## SERVICE BULLETIN MAINTENANCE OF WAY EQUIPMENT

**DATE:** 11-17-2003 **BULLETIN NO:** 03-026

**TITLE:** JACKING CYLINDER ROD EYE INTERFERENCE

**PRODUCT SERIES / MODEL:** 6700S Tampers

**FIGURE 1  
JACKBEAM LIFTING EAR**

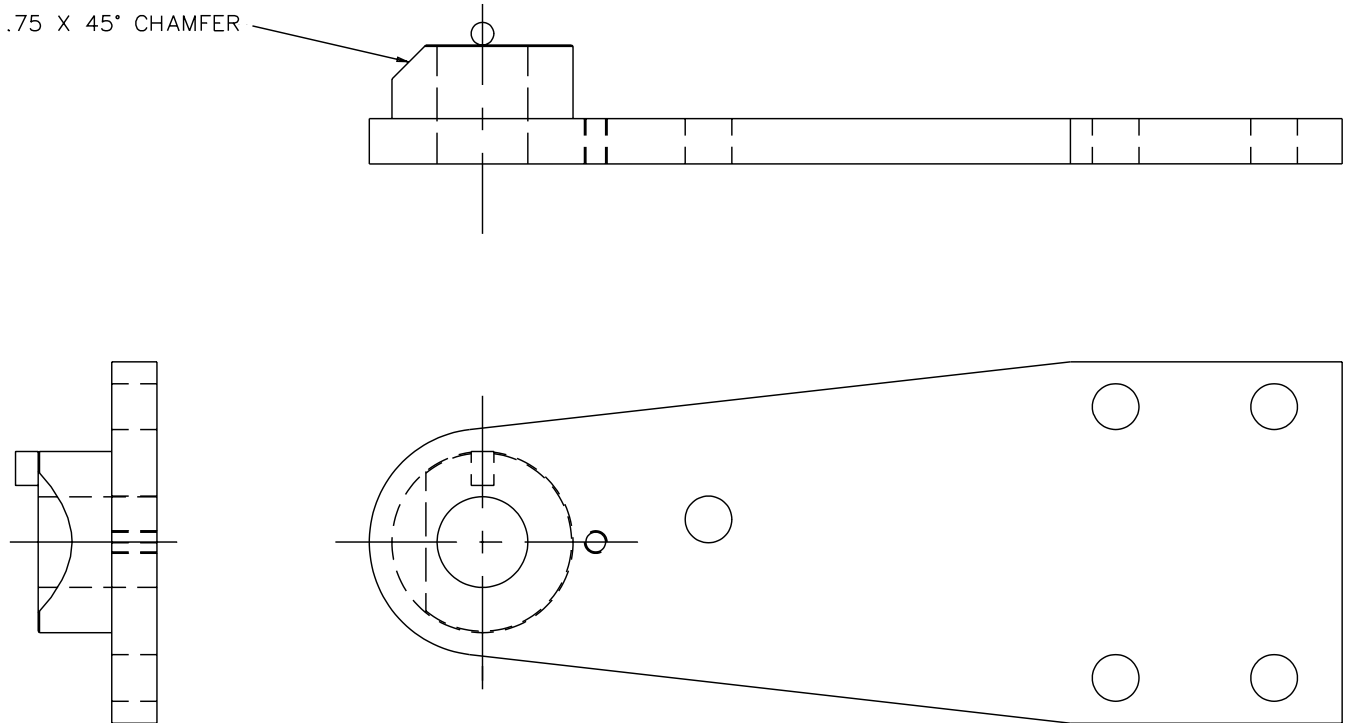
**SUMMARY:** There have been several instances where the weld on the Jacking Cylinder rod eye can interfere with the boss on the Jackbeam Lifting ears. This interference usually occurs when the Jackbeam is all the way forward or rearward and the Jacking cylinder is completely retracted. When this condition exists, there is the possibility of putting a side load on the cylinder rod which can in turn cause premature wear to the cylinder barrel, piston and rod bearing. The interference can be eliminated by grinding a 3/4" x 45° chamfer on the top side of the Jackbeam Lifting Ear Boss.

1. Lower the Jackbeam to the rail.
2. Remove the cylinder pin connecting the cylinder to the Jackbeam.
3. Swing the Jacking cylinder out of the way and secure to provide clearance for grinding.
4. Grind a 3/4 inch x 45° bevel on the top side of both Jackbeam cylinder ears as shown in Figure 1. Be sure to remove all sharp edges, burrs, etc.
5. Re-assemble the cylinder to the Jackbeam.
6. Repeat procedure to rework the Jackbeam lifting ears on the other side of the machine.
